Subject: **Docket Nos. 50-361 and 50-362**
Amendment to SONGS Units 2 and 3 NPDES Permits
San Onofre Nuclear Generating Station Units 2 and 3

ADDENDUM NO. 1 FOR SAN ONOFRE NUCLEAR GENERATING STATION, UNIT NOS. 2 AND 3, ORDER NO. 99-47 AND 99-48, NPDES PERMIT NOS. CA0108073 AND CA0108181.

ADDENDUM NO. 1

WASTE DISCHARGE REQUIREMENTS
FOR
SOUTHERN CALIFORNIA EDISON COMPANY
SAN ONOFRE NUCLEAR GENERATING STATION, UNIT 2 AND UNIT 3
SAN DIEGO COUNTY

ATTACHMENT 1 Water Quality Station Locations

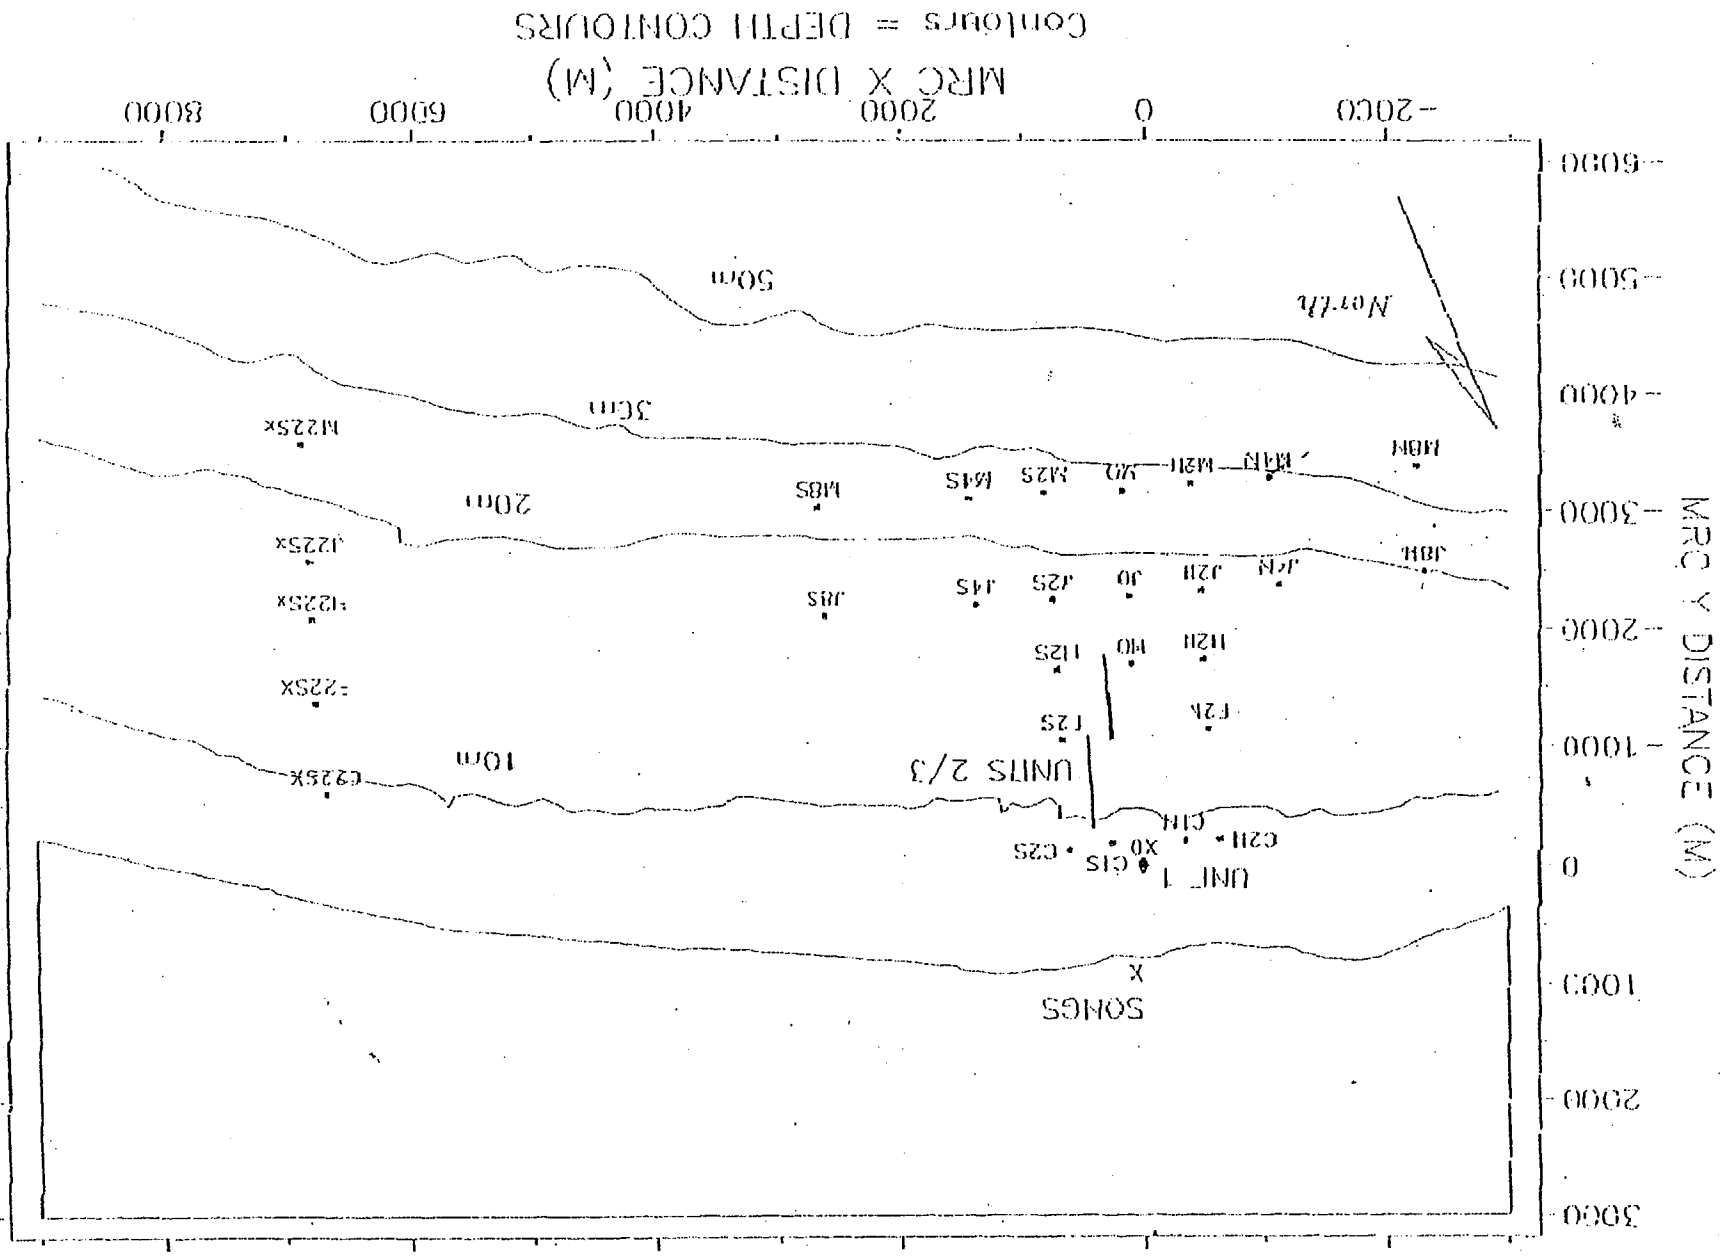
6. This addendum also changes the location of three control stations to the receiving water monitoring and reporting program that is shared by Unit Nos. 2 and 3. The modification will improve the usefulness of the deep-water turbidity data.

ATTACHMENT 2
Coliform Monitoring Stations

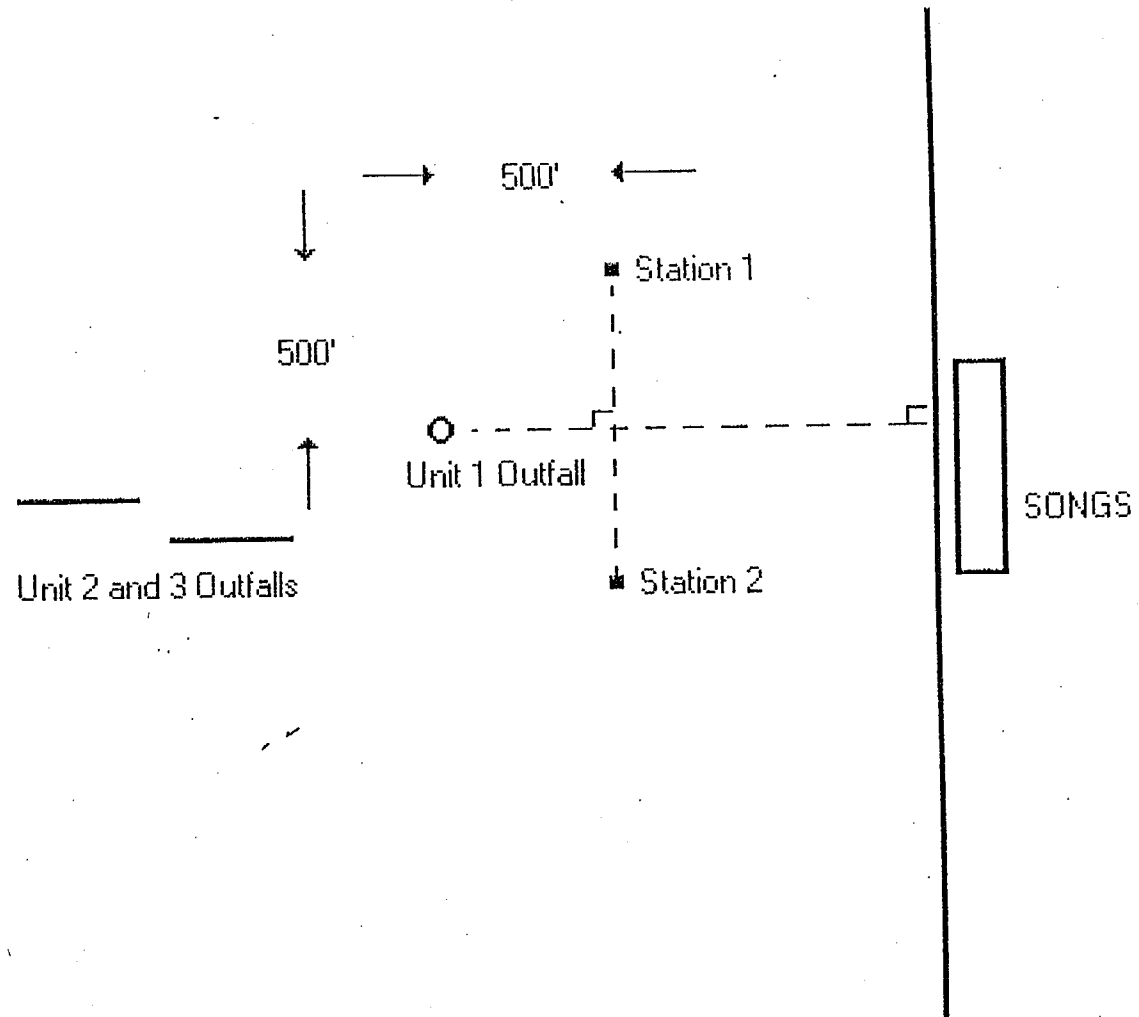
Monthly grab sampling shall occur at two locations shown in Attachment 2. The two locations shall be located 500 feet shoreward of the Unit 1 Outfall. Station one shall be located 500 feet upcoast and the station two shall be located 500 feet downcoast. Samples shall be taken from surface, mid-depth, and bottom and be analyzed for total coliform density, fecal coliform density, and enterococcus density. Results shall be reported in units of number of organisms per/100ml.
